ADDENDUM NO. FOUR
THORNTON WATER PROJECT
SOURCE WATER PUMP STATION
PROJECT NO. 12-777XP
CITY OF THORNTON, CO

DATE: July 16, 2026

PURPOSE: To provide additional information and clarification to the solicitation documents for the above-referenced Project.

A PLAN
SCALE: 1/4" = 1'-0"

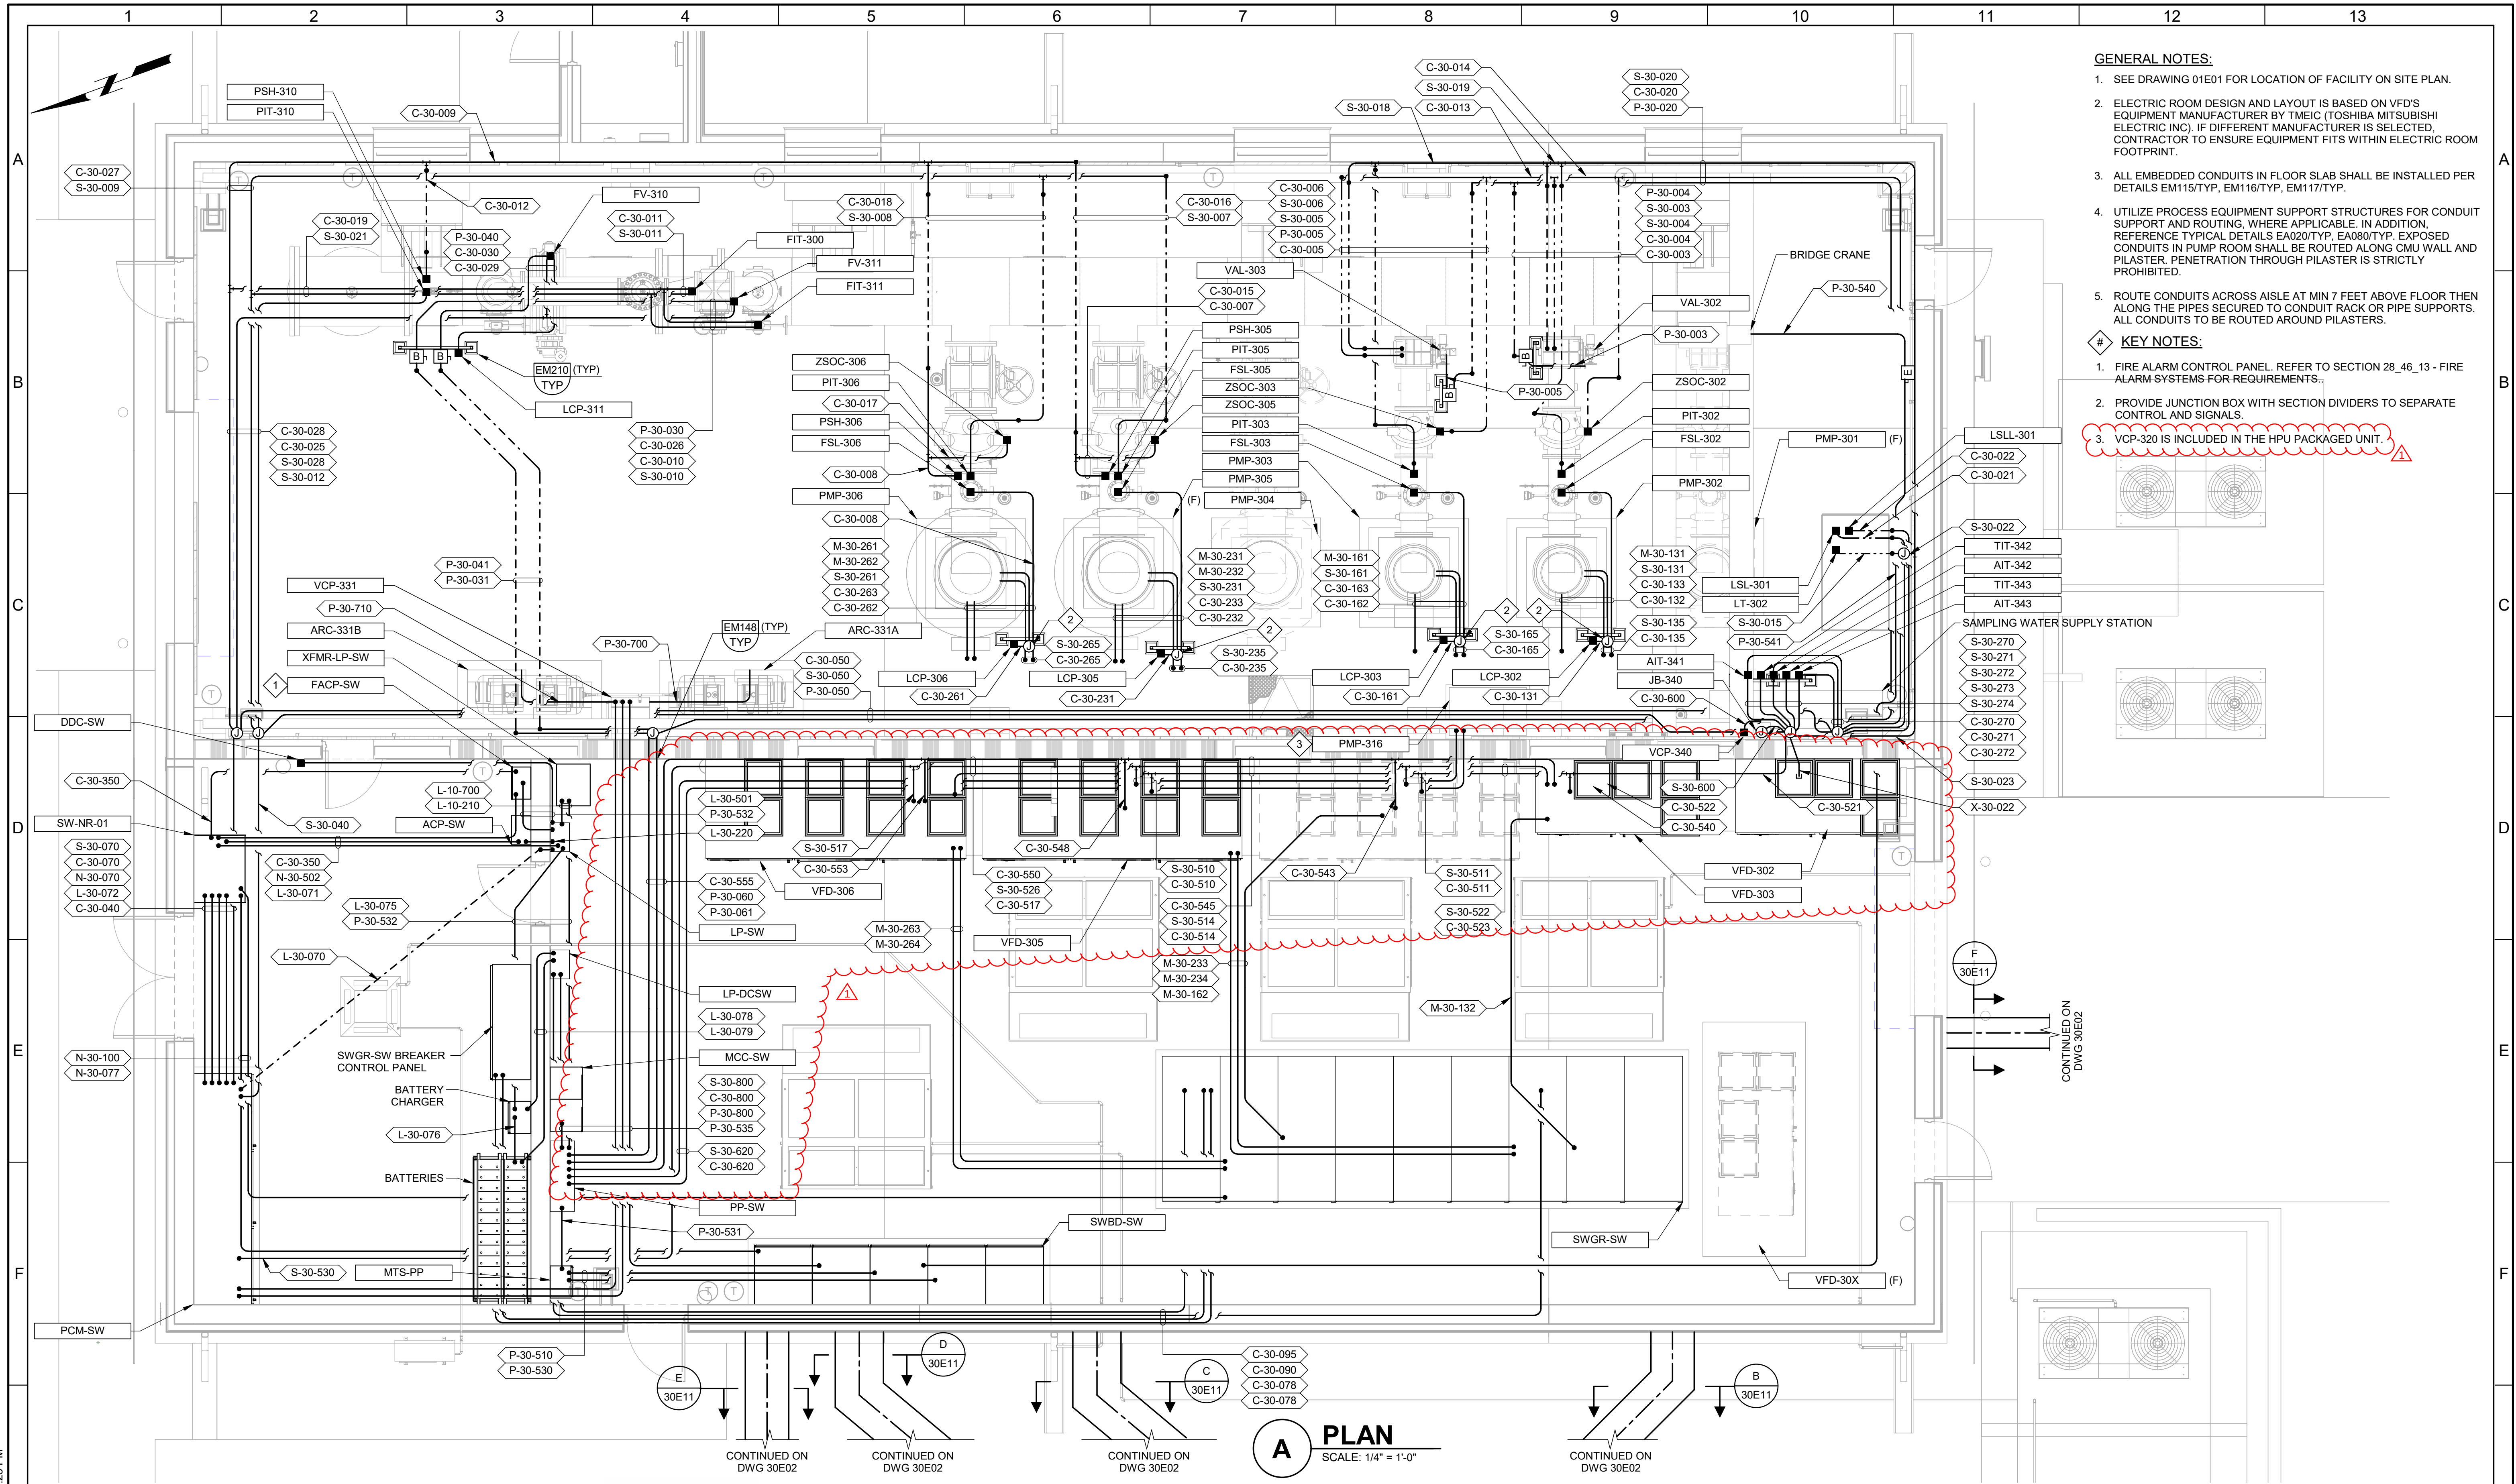
10	1. It appears that the following loads should be added to the panel schedule for Panel LP-DCSW on drawing 30E15: SWGR-SW CUBICLE 2D (52-T1), SWGR-SW CUBICLE 2F (52-T2), and SWGR-UT_1 CUBICLE 1 (52-U1 & RELAY) FUTURE. Is that correct?	Add SWGR-SW CUBICLE 2D (52-T1) and SWGR-SW CUBICLE 2F (52-T2) to the panelboard schedule. SWGR_UT1 Cubicle 1 is shown on circuits 18/20. A circuit can be reserved for future SWGR-UT2 Cubicle 1. This sheet has been updated and included in Addendum No. 4
11	2. Can you please supply the size of the batteries and charger for the 125V DC battery system? If these haven't been sized, can you provide the load required to operate the breakers for each cycle along with the length of time the operations each take?	The batteries and charger are to be sized by the Contractor based on equipment provided per section 26_33_01-1.04.D.
12	3. Can you provide an MCC spec for the Pump Station?	Low voltage MCCs are specified in section 26_24_20.

CIVIL
CHEMICAL BUILDING -
GRADING, PAVING & DRAINAGE DEMOLITION PLAN 1

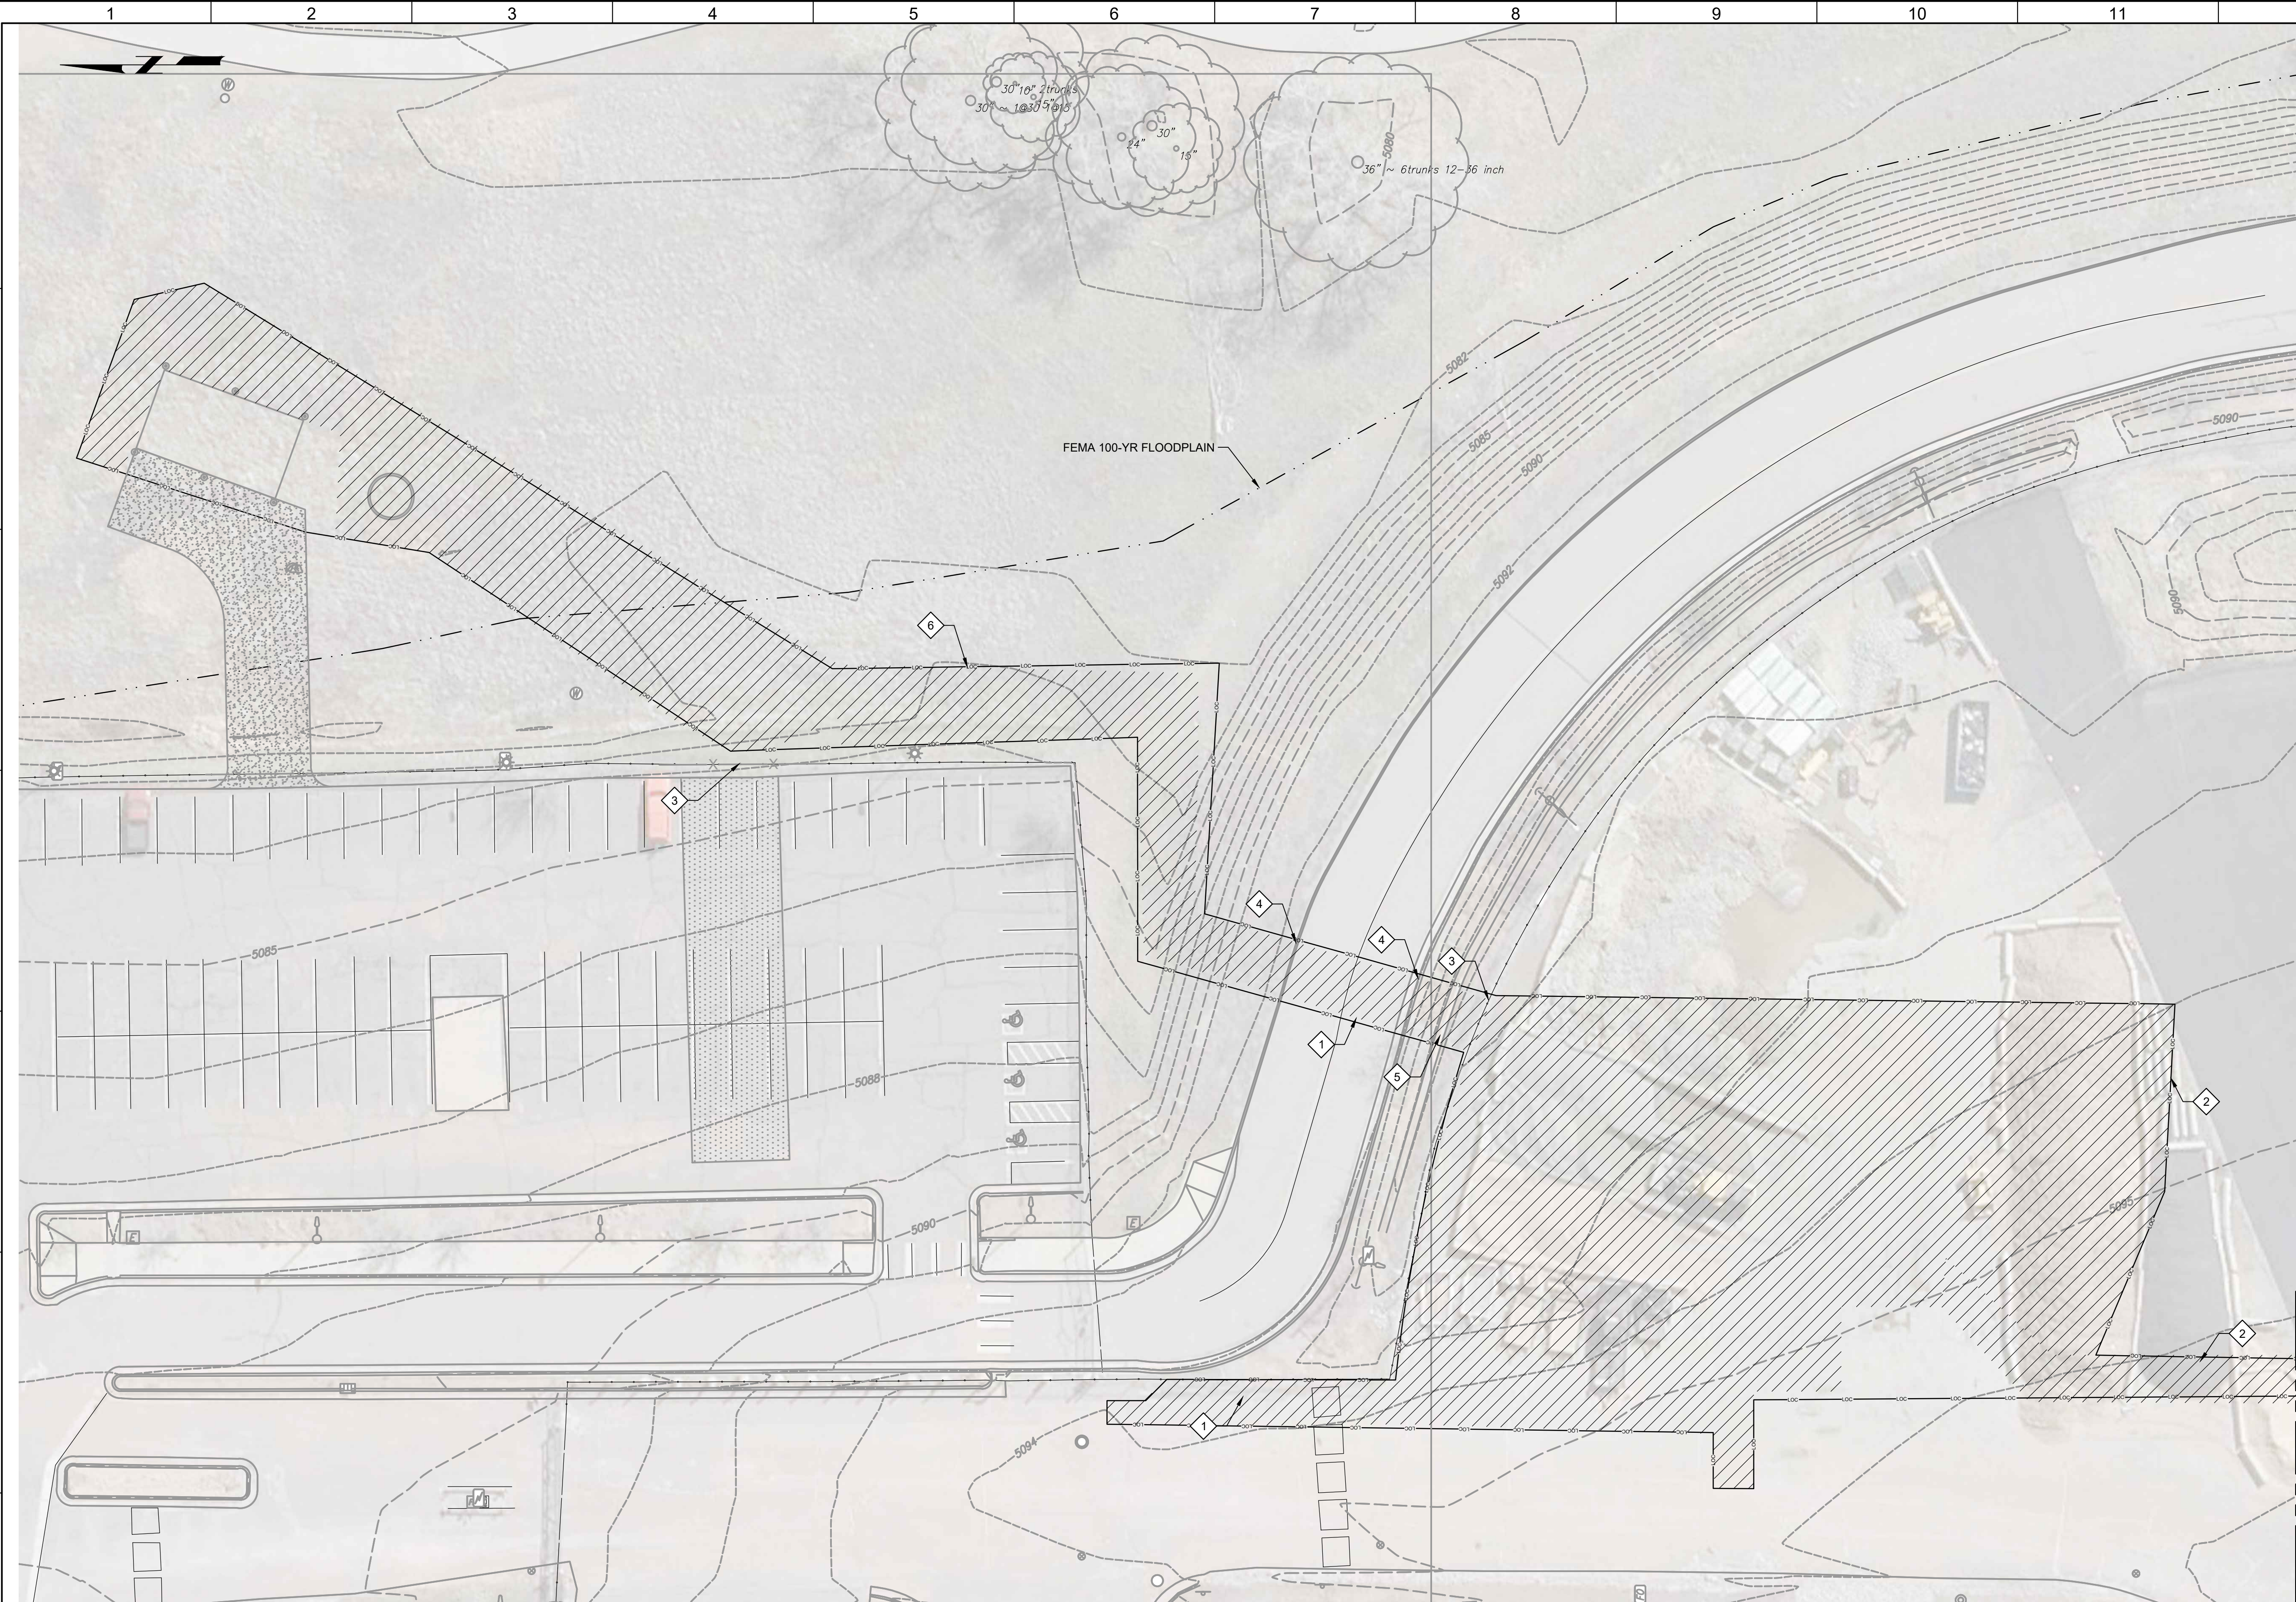
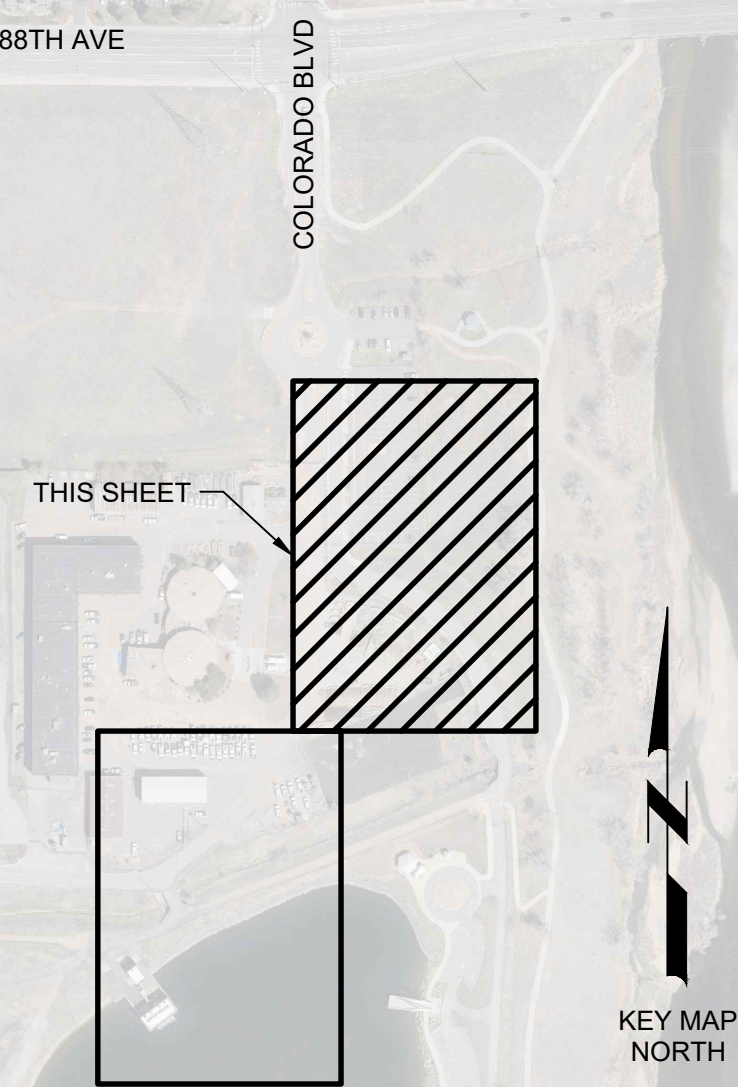
- 1. The following drawings are deleted in their entirety and replaced with the revised drawings: 50C01, 50C03, 50S06: (under separate cover).

1. REMOVE ASPHALT PAVEMENT.
2. MATERIAL STOCK PILES, STORAGE CONTAINERS, EQUIPMENT, BLOCK WALLS, AND OTHER MATERIALS WILL BE REMOVED BY THE OWNER.
3. REMOVE FENCE.
4. REMOVE CONCRETE CURB AND GUTTER.
5. REMOVE CONCRETE CHANNEL.
6. CLEAR AND GRUB EXISTING VEGETATION TO LIMITS SHOWN.
